IFB No.        **16-48 Brookview Elementary School Additions and Renovations**

RE:        **ADDENDUM NO. 4**

Project: **16-48 Brookview Elementary School Addition Project**

#### **Sheet C04 – Layout/Utility Plan**

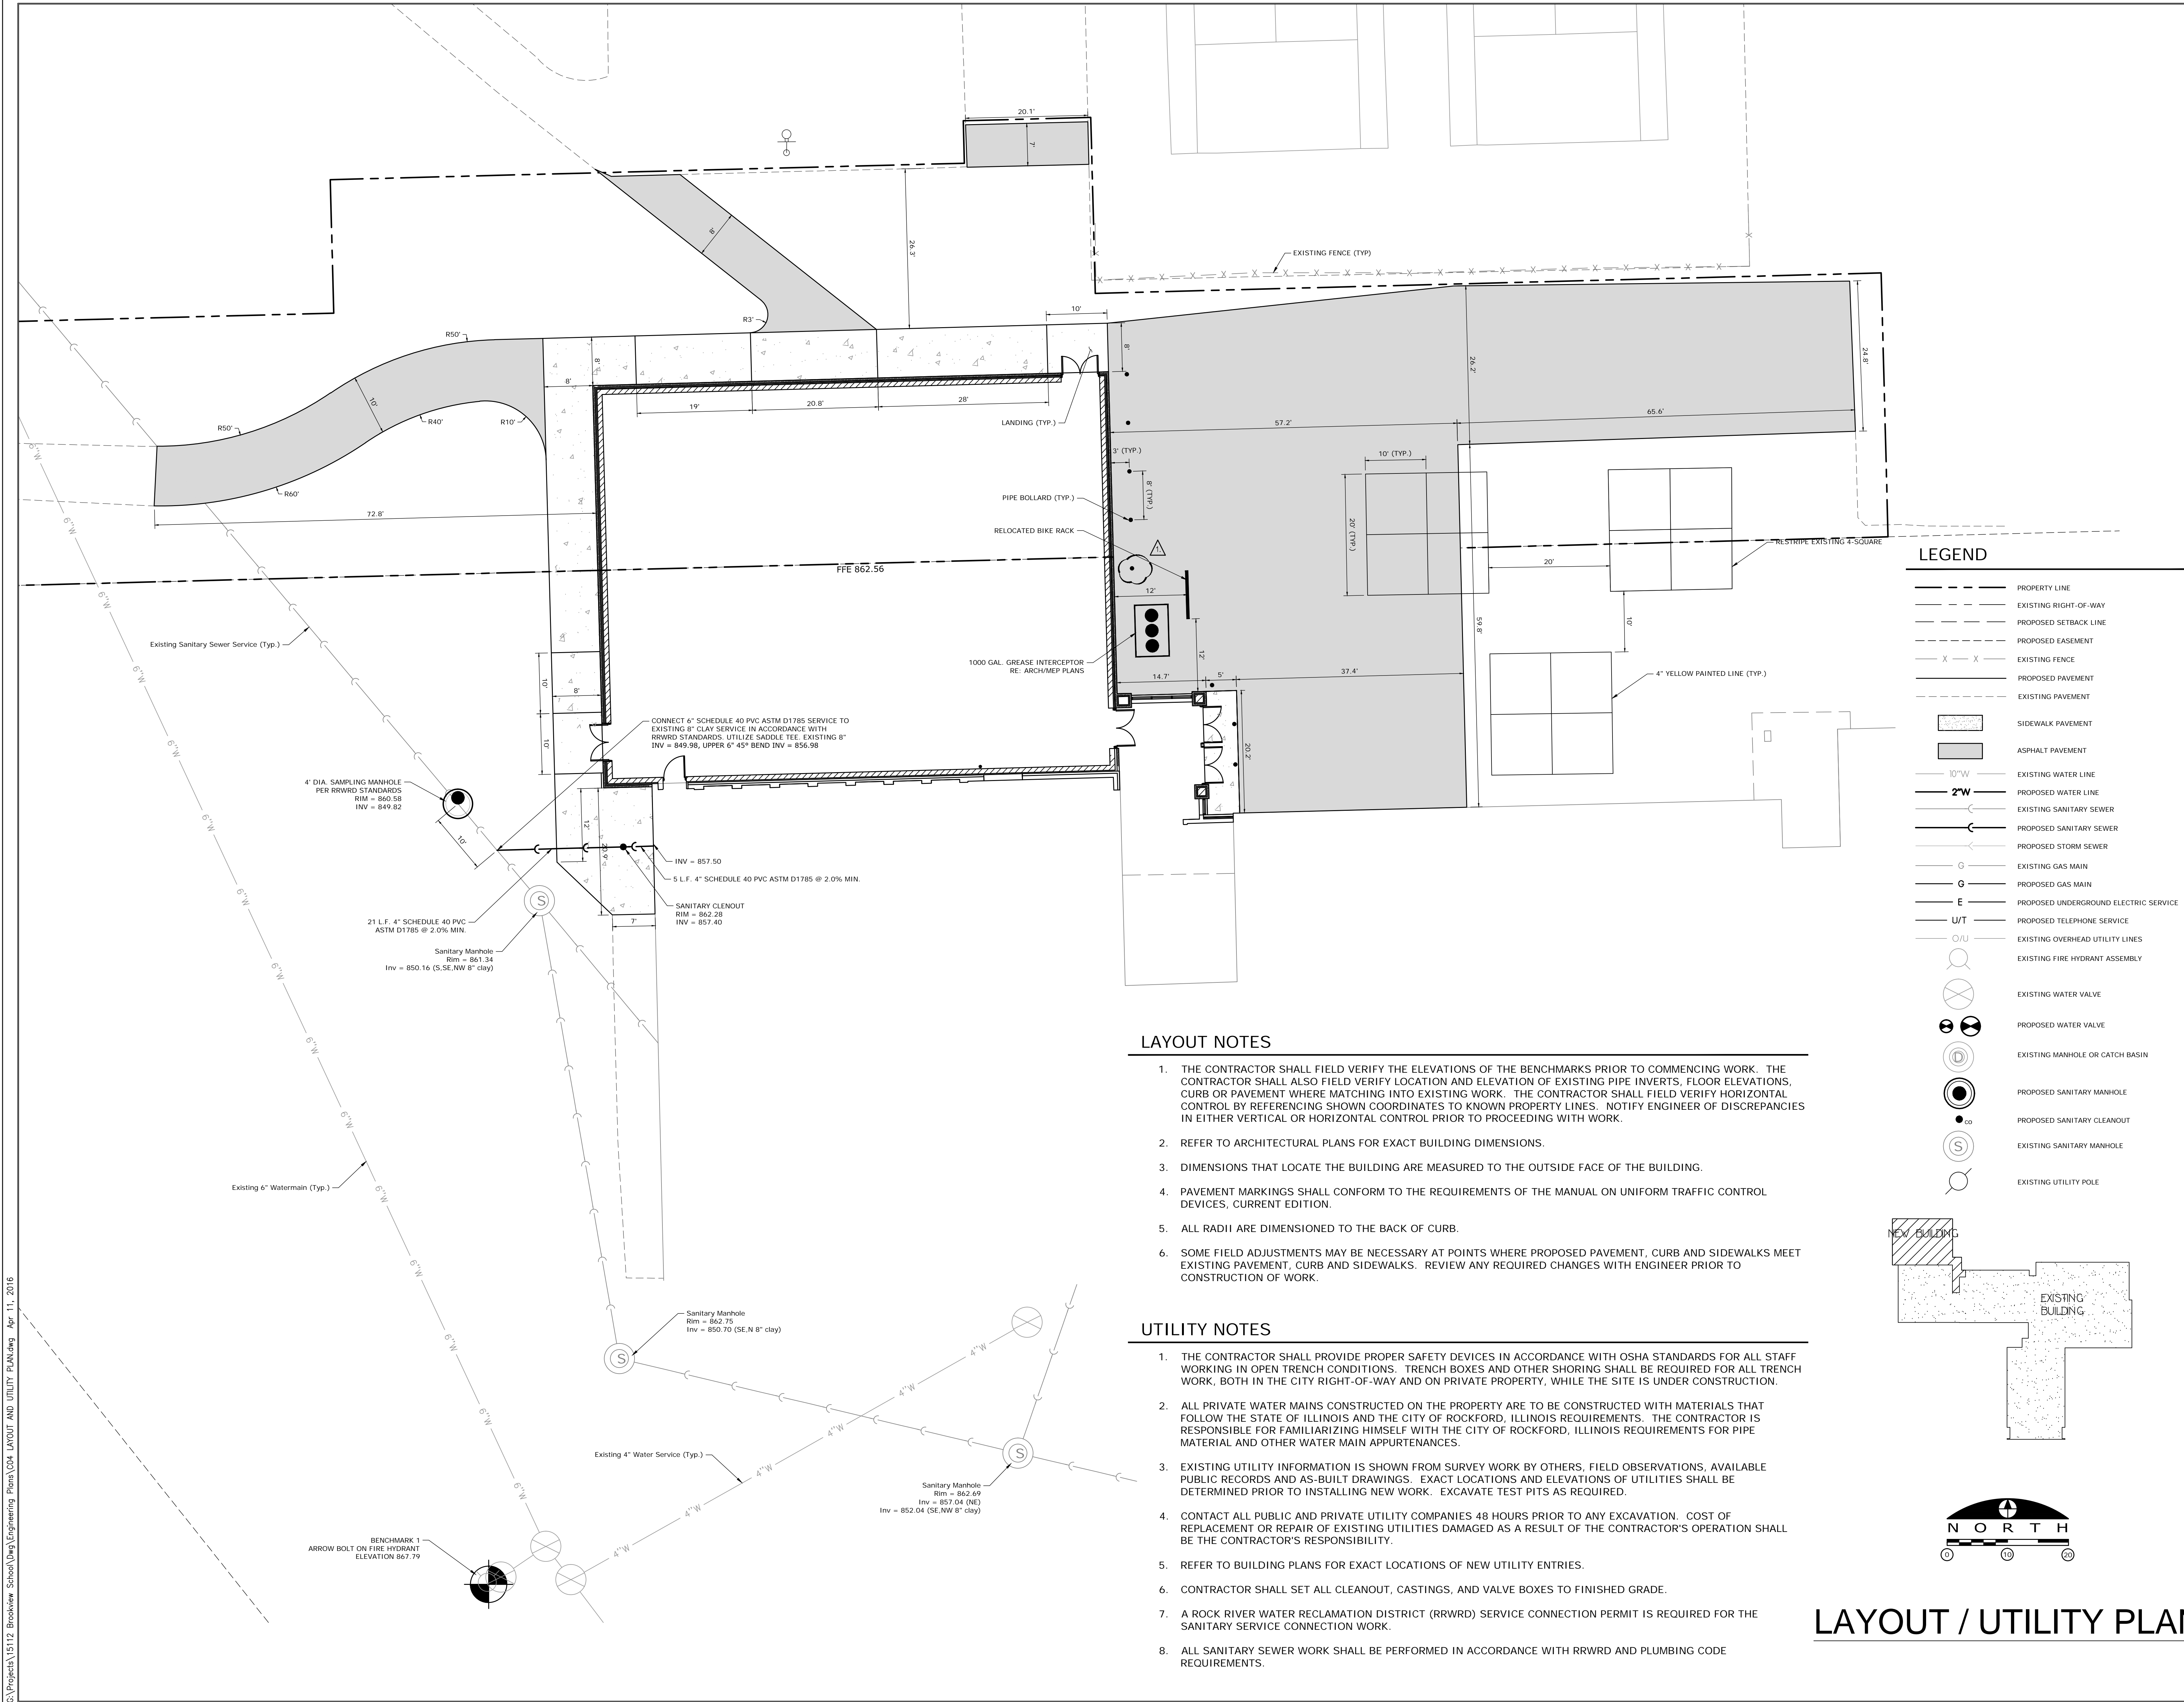
1. An additional bollard location has been indicated along the gymnasium wall. There shall be five (5) bollard in total provided along said wall.

STANDARD BOLLARD DETAIL

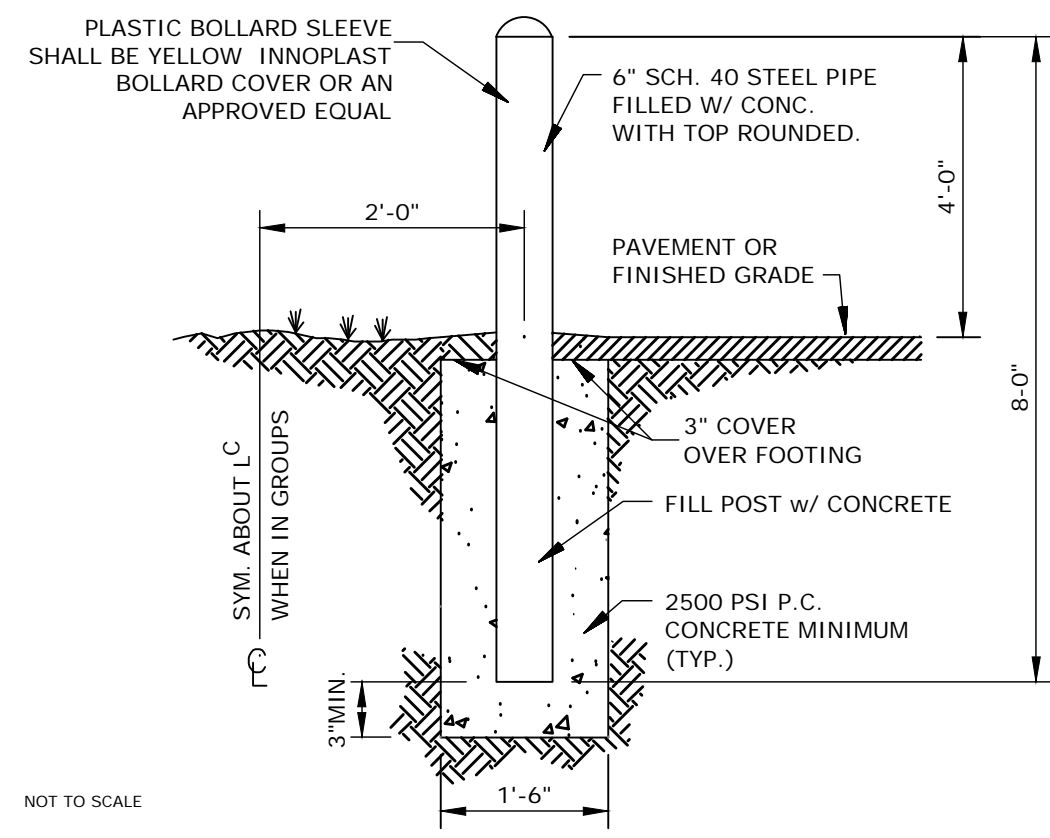
1. The stainless steel bollard detail has been omitted from the plans. The contractor shall utilize the mild steel pipe bollard.
2. The Typical Ramp Detail has been omitted from the plans as not ramps are required for the proposed improvements.
